Technical Bulletin TB2019-03

Regarding a change to the Pietro Fiorentini Installation Manual

April 2nd, 2019

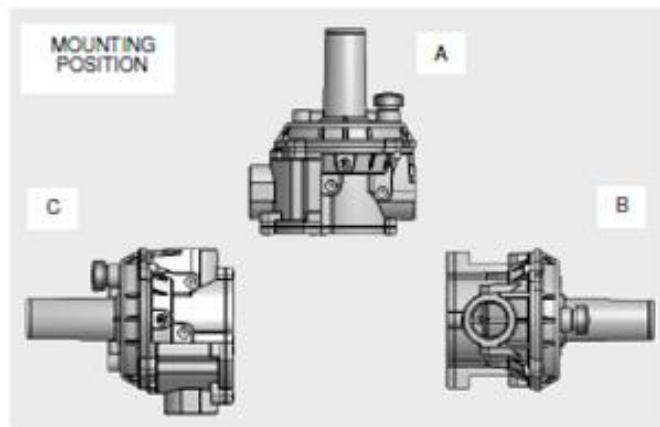
This Technical Bulletin provides information about a change in the Pietro Fiorentini Operating and Maintenance Manual regarding the mounting position of the Pietro Fiorentini line pressure regulators. The Pietro Fiorentini line regulator cannot be mounted upside down. The drawing below shows approved mounting positions.
